**SUBJECT: THREE MILE ISLAND, UNIT 1 (TMI UNIT 1)
OPERATING LICENSE No. DPR-50
DOCKET No. 50-289
ADDITIONAL INFORMATION - LICENSE CHANGE APPLICATION
NO. 291 – ONCE THROUGH STEAM GENERATOR (OTSG) SURVEILLANCE
SPECIFICATIONS APPLICABILITY FOLLOWING CYCLE 13**

TMI Unit 1 Response to NRC Request for Additional Information (RAI)

**TMI Unit 1 Response to NRC Request for Additional Information on Technical
Specification Repair Criteria for Volumetric Inner Diameter (ID)
Intergranular (IGA) Attack Degradation**

Figure 1

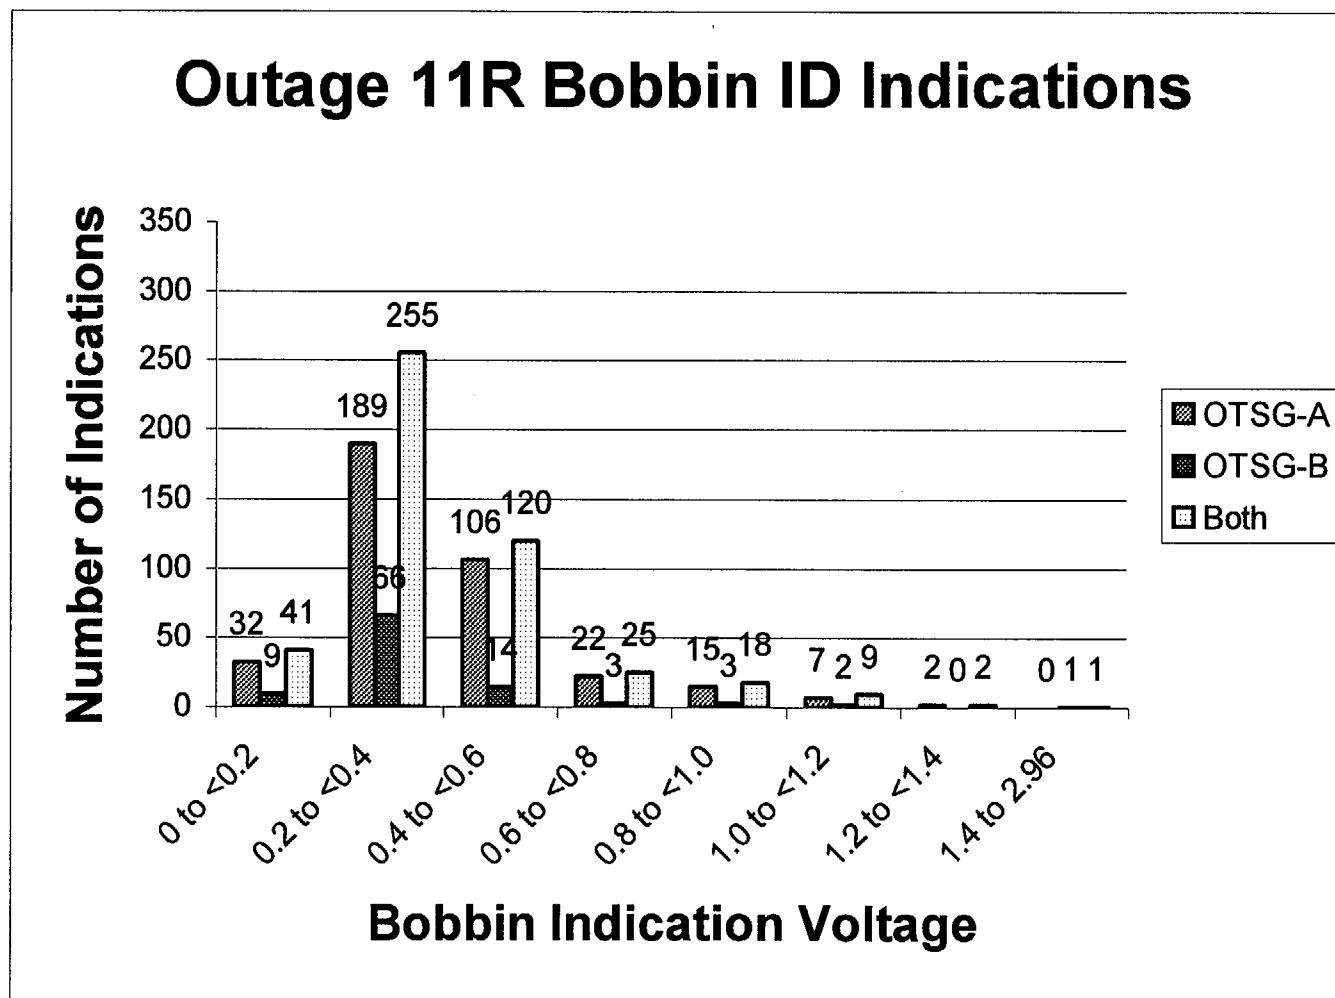
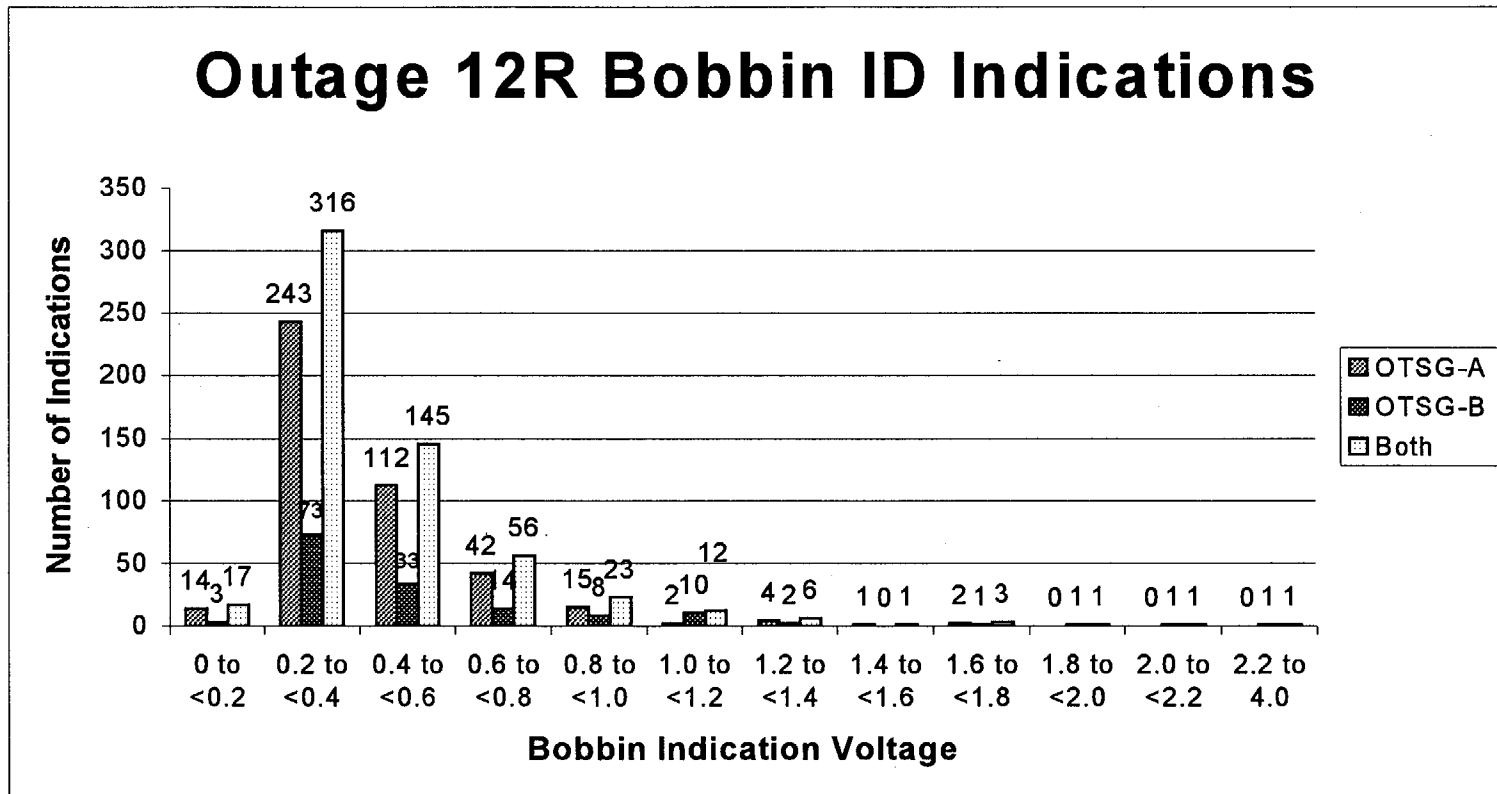
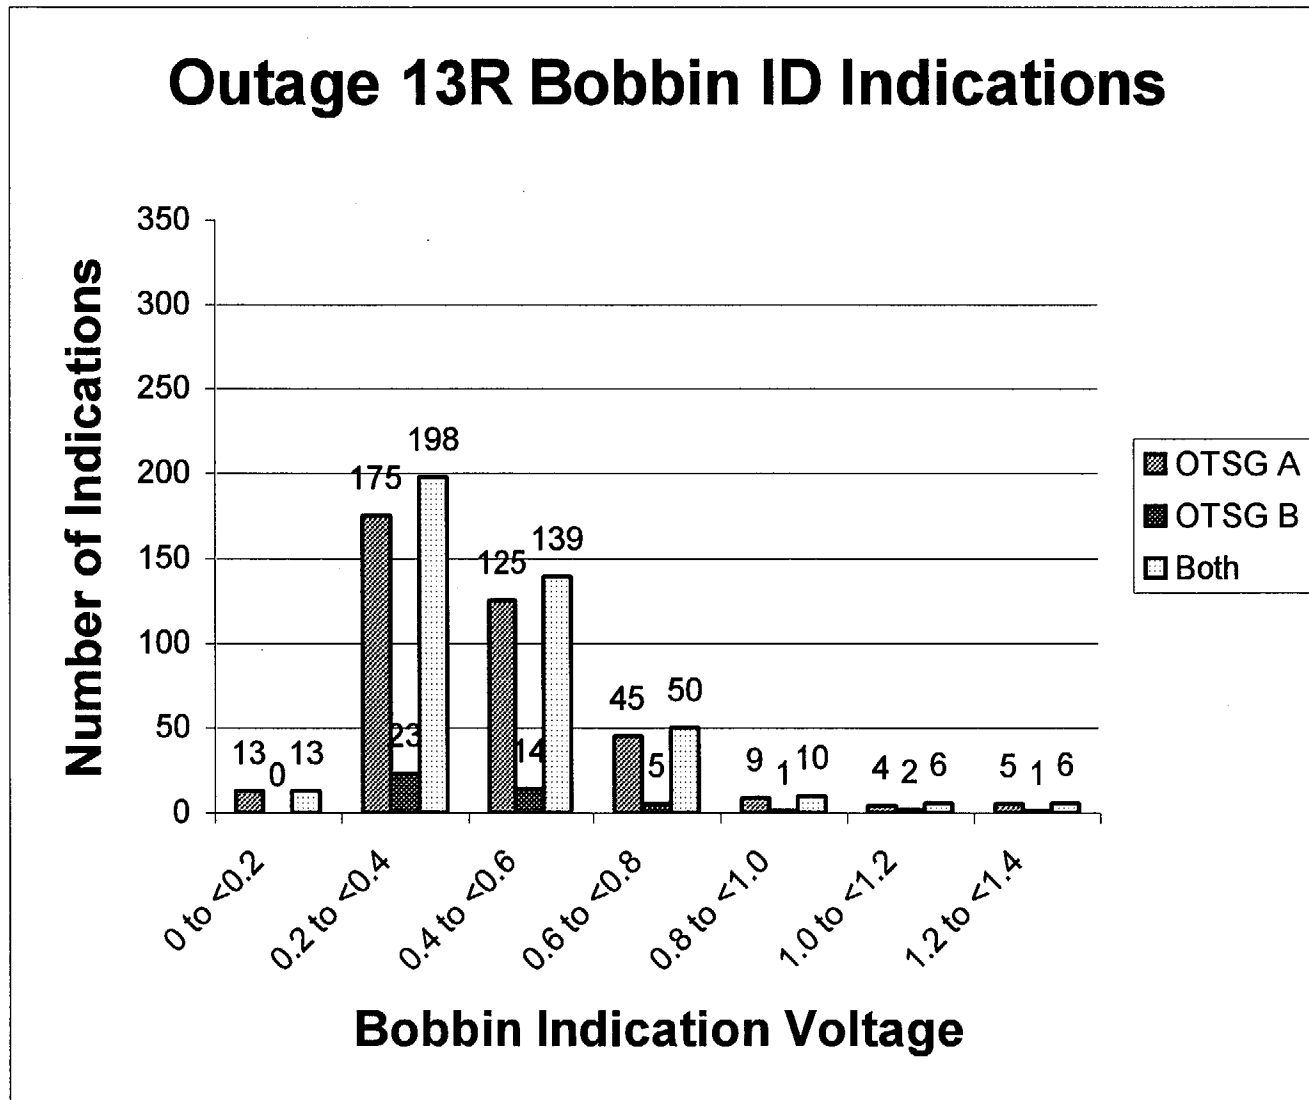
For outages 11R to 13R, please provide the total number of ID IGA indications found below the kinetic expansion region of the steam generators during each outage in a table, separated into 0.2V (as measured by bobbin) bins.

Figures 1 through 3, which follow, provide binned voltage plots of 0.540" diameter bobbin coil indications that were ID in nature and were recorded as "BVC" or a measured through wall extent, regardless of whether the indication was confirmed by MRPC. The 0.540" bobbin coil indications are all below the kinetic expansion region. The 0.540" bobbin coil is not used in the kinetic expansion or the kinetic expansion transition regions.

Attachment 4
TMI-1 ID IGA/SCC 400 kHz Bobbin Coil Sizing Performance

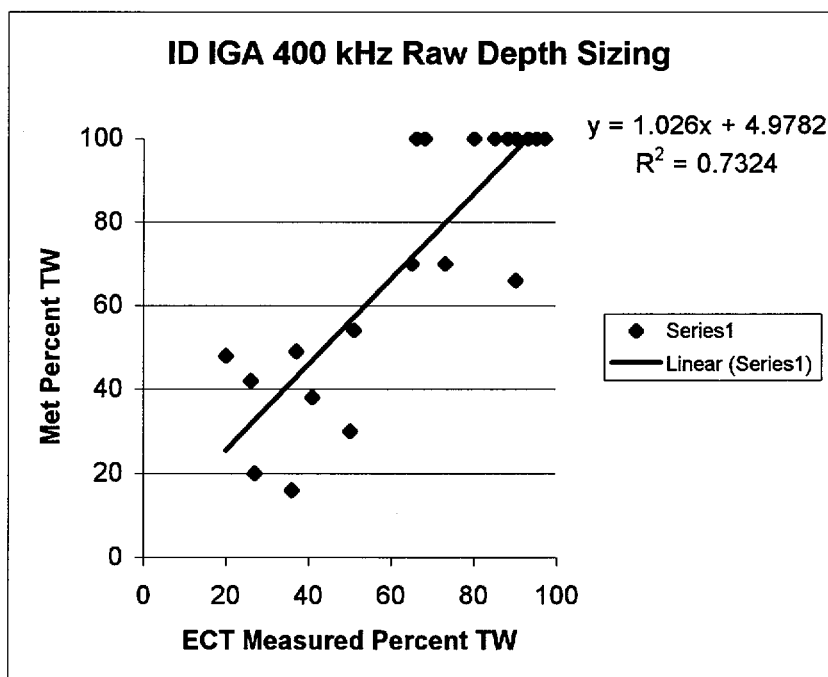
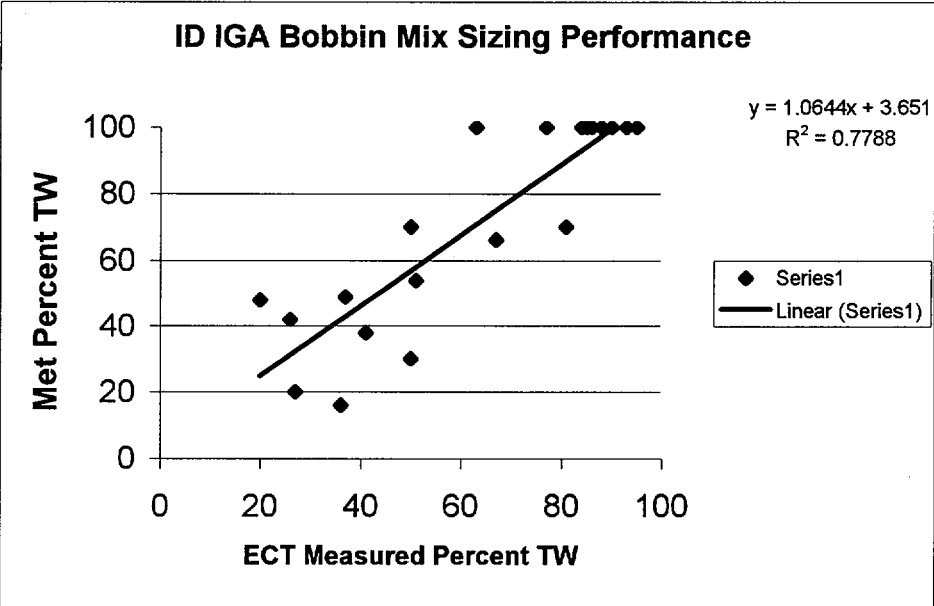
Referring to page 42 and 43 in the April 25, 2001, meeting handout, please correct the tabular information given under the graphs. Please discuss how IGSCC is representative (or bounding) the ability of the technique to size ID IGA.

The graphs and tabular information are now provided in the response to RAI Question No. 6.

The tabular information on Page 42 of the April 25, 2001, meeting handout was correct.

The tabular information on Page 43 of the April 25, 2001, meeting handout was not correct. (The information from Page 42 was inadvertently repeated on Page 43.)
